## MEMORANDUM

**TO:** Wei Zeng, Georgia Environmental Protection Division  
**FROM:** Sorab Panday, GSI Environmental  
**RE:** Responses to Georgia EPD Modeling Questions

### EXECUTIVE SUMMARY

**Figure 1  
 Aerial Distribution of Consolidated Black Sands**  
 Twin Pines Minerals, LLC  
 St. George, Charlton County, Georgia

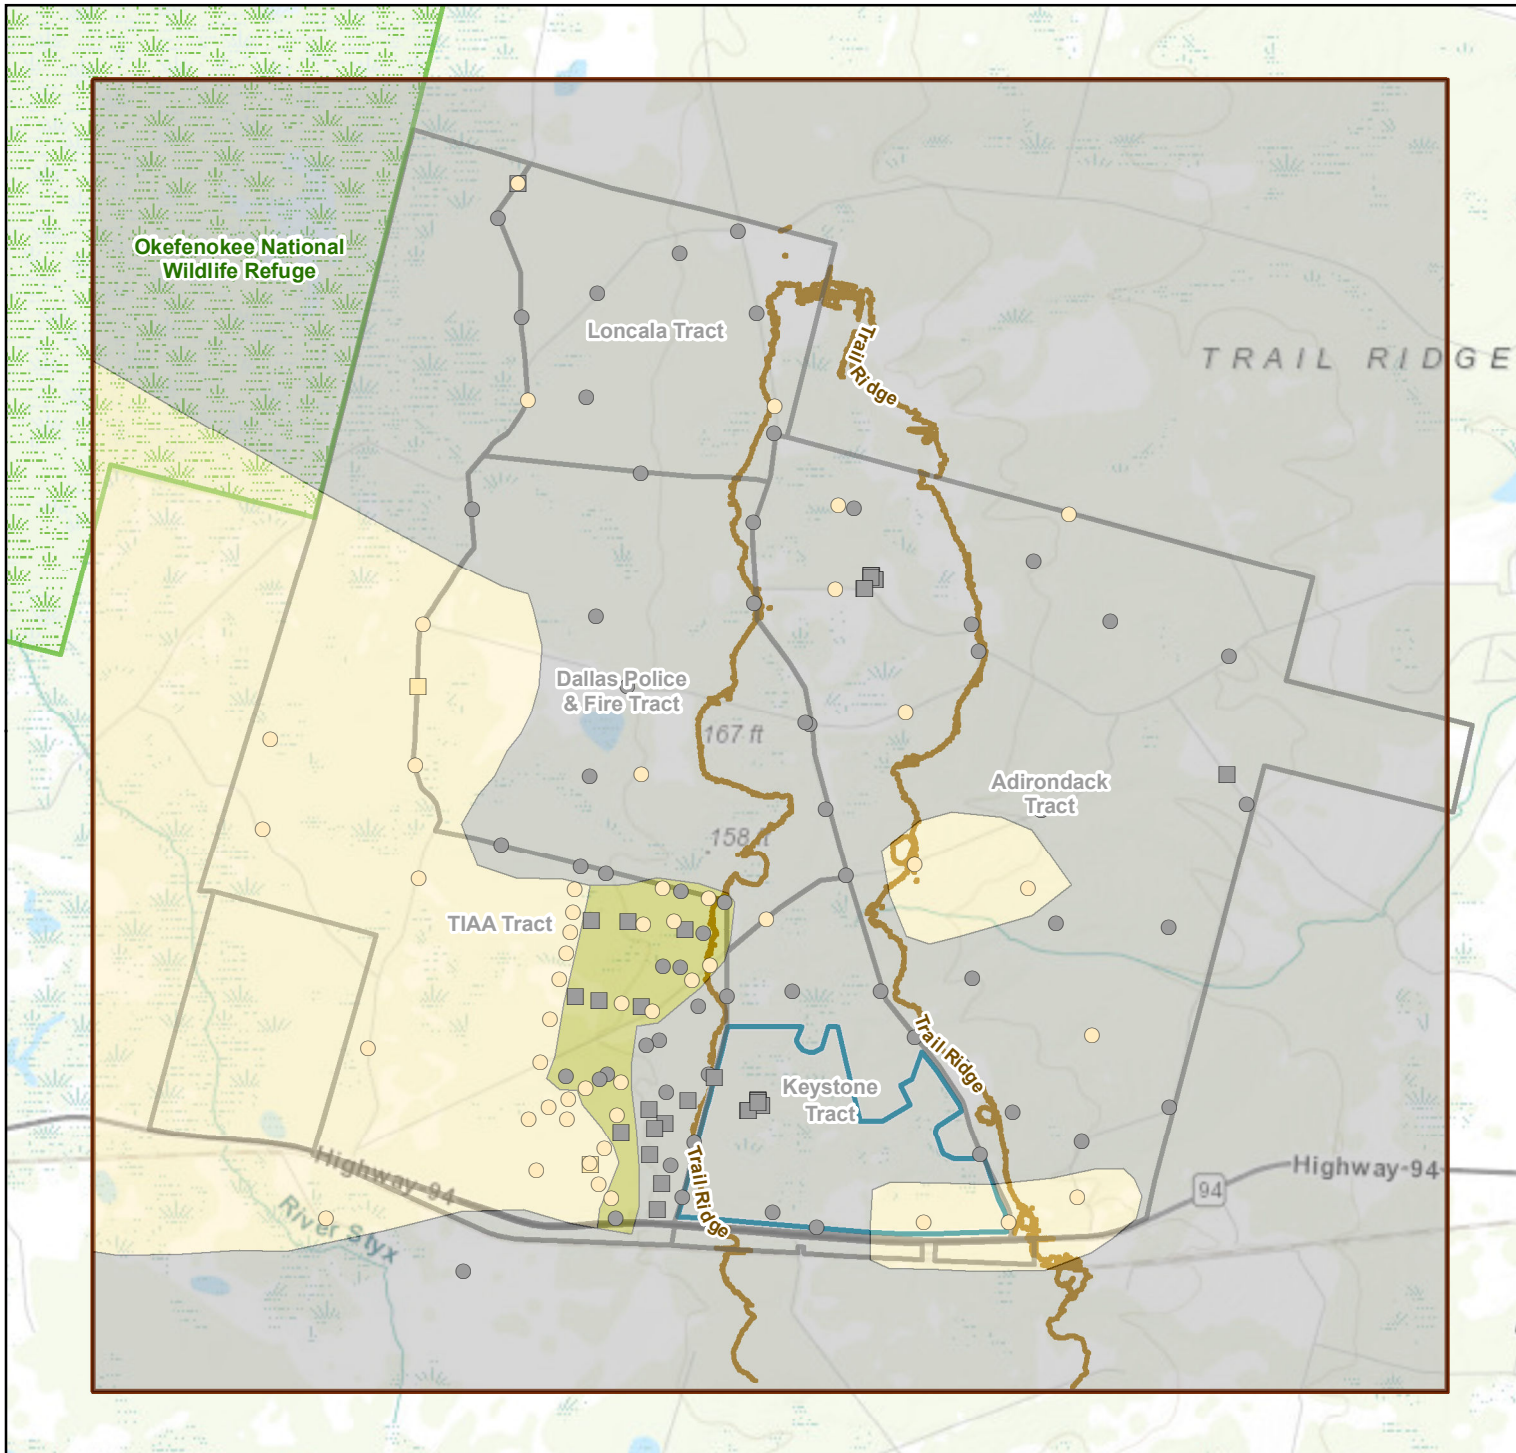
**Question 1:** What is the distribution of CBS within the study domain?

**Response:** The CBS cover approximately 70% of the study area based on cross-sections evaluated by GA EPD (Kennedy, 2020b). My evaluation confirmed GA EPD's calculations: **Figure 1** (reproduced from Figure 4 of GSI, 2021) shows the locations where CBS were present in the soil boring logs. As noted in GSI (2021), there are distinct zones (demarcated visually on the figure) where CBS do and do not exist in the logs. There is also an area just to the west of Trail Ridge near the southern portions of the model domain, which may be a transition zone where boring logs may or may not show CBS presence. Note that this is the location of the highest density of data. The CBS are present in 65% of the borings and cover approximately 77% of the study area, as interpolated in the figure.

**Response:** With the exception of two borings along the southeast corner, the CBS were found in all borings within the proposed mining area. The thickness of the CBS is variable where present. For the base case pre-mining condition, the groundwater flow model used boring logs with greater than 1 foot thickness of CBS to interpolate the values across the domain, as shown on **Figure 2** (reproduced from Figure 9 of GSI, 2021). The model was calibrated using water levels and water level differences across the CBS and therefore also evaluates connectivity information across the CBS, which may also indicate absence (or discontinuity) in the CBS. The calibrated hydraulic conductivity of the CBS unit in the model is shown on **Figure 3** (reproduced from Figure 27 of GSI, 2021). As indicated on the figure, the proposed mining area is covered by lower hydraulic conductivity materials, except within its southeastern portion (where **Figure 1** shows a lack of CBS in the boreholes).

**Figure 4**  
**Water Table Difference**  
**No Bentonite Soil Amendment**  
 Twin Pines Minerals, LLC  
 St. George, Charlton County, Georgia

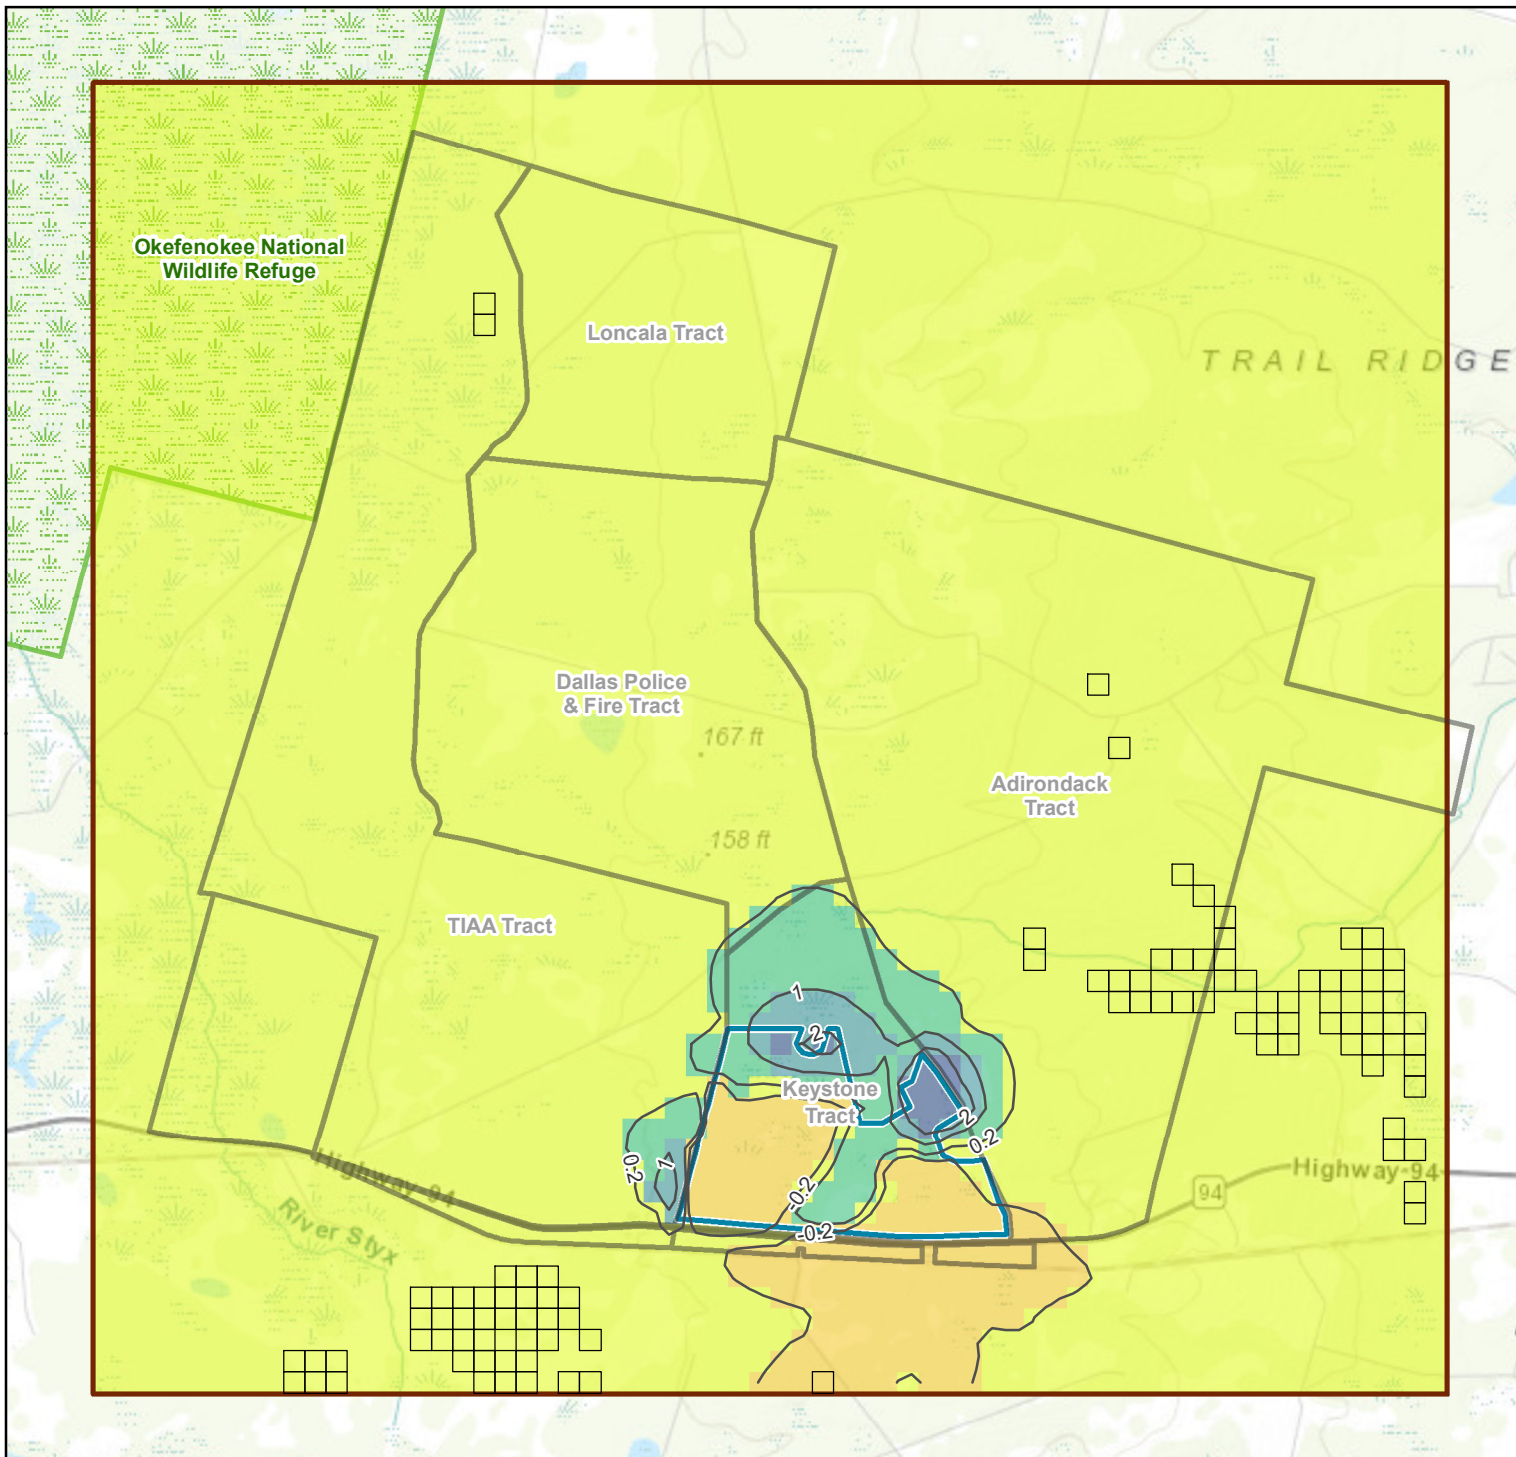
**Question 3:** In the model runs showing the post-mining condition with the soil amendment layer, was the bentonite layer placed throughout the proposed mining area during reclamation, and what would be the impact of "holes" in the bentonite layer where CBS does not exist?

conditions, which included a simulation with no bentonite layer. **Figure 4** (reproduced from Figure 39 of GSI, 2021) shows the impact on the water table between pre- and post-mining conditions with no bentonite amendments in the reclaimed sands, indicating that the impacts are restricted only to the proposed mining area and immediate vicinity, with largest drawdowns ranging from 2.01 to 6.65 feet and water level increases of up to 1.76 feet. **Figure 5** (reproduced from Figure 41 of GSI, 2021) shows the impact of a continuous 10.9% bentonite amendment layer on the water table, indicating that the impacts are restricted only to the proposed mining area and immediate vicinity, with largest drawdowns of up to 2.03 feet near the periphery of the mined area and water level increases of up to 5.31 feet in the middle of the mined area.
